## Access Compliance Report Public Rights-of-Way (Curb Ramps)

Intersection ID: 15094Main Street: ALBEMARLE\_RDCross Street: REDDMAN\_RDLocation:SWADA ID: 967EA1BD3025Ramp Type: PerpInitial Pass/Fail: FailOverall Compliance: NoSeverity Score: 33.75

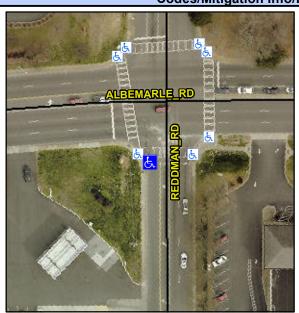
-		
STATE OF	Possible Solutions:	9
The Park	Remove & Replace Entire Ramp.	ı
-		ı
		1
100		ı
		ı
1		ı
6	Surveyor Notes:	ı
	N/A	ı
		1
1		
7		
	PROW/ADA:	ı
1	Not Found, R304.5.1, R304.2.2,	1
-	R304.5.3	ı
		ı
		_
		ı

Field Measurements/Component Compliance							
Comp	liance Description	Data	Comp	liance Description	Data		
N/A	Ramp Length (in)	59.0	No	Ramp Slope (%)	11.5		
No	Ramp Width (in)	40.0	No	Ramp XSlope (%)	6.4		
N/A	Flare Type LT	N/A	N/A	Flare Type RT	N/A		
N/A	Flare Slope LT (%)	N/A	N/A	Flare Slope RT (%)	N/A		
N/A	Flare Traversable LT?	N/A	N/A	Flare Traversable RT?	N/A		
N/A	Landing Length (in)	N/A	N/A	DWS Provided?	N/A		
N/A	Landing Width (in)	N/A	N/A	DWS Contrast?	N/A		
N/A	Landing Slope (%)	N/A	N/A	DWS Length (in)	N/A		
N/A	Landing X Slope (%)	N/A	N/A	DWS Full Width?	N/A		
N/A	Landing Curb? (Y/N)	N/A	N/A	DWS Offset (in)	N/A		
N/A	Shared Landing?	N/A					
N/A	Gutter Ponding?	N/A	N/A	Gutter Slope (%)	N/A		
N/A	Gutter Lip Ht (in)	N/A	N/A	Gutter X Slope (%)	N/A		
N/A	Painted X Walk1?	Yes	N/A	Painted X Walk2?	N/A		
	X Walk 1 Direction	To SW		X Walk 2 Direction	N/A		
N/A	X Walk 1 Width (in)	112.0	N/A	X Walk 2 Width (in)	N/A

X Walk 1 Slope (%)	2.7		X Walk 2 Slope (%)	N/A		
	X Walk 1 X Slope (%)	8.7		X Walk 2 X Slope (%)	N/A		
N/A	Ramp inside XWalk1?	Yes	N/A	Ramp inside XWalk2?	N/A		
	Road Slope (%)	N/A	N/A	Clear Space?	N/A		
	Road X Slope (%)	N/A	N/A	Clear Space to XWalk (in)	N/A		
N/A	Any Obstructions?	N/A	N/A	Storm Grate/Utility Hazard?	N/A		
	Obstruction Type			Storm Grate/Utility Type			
		N/A			N/A		
			Yes	Surface Condition? (G/P)	Good
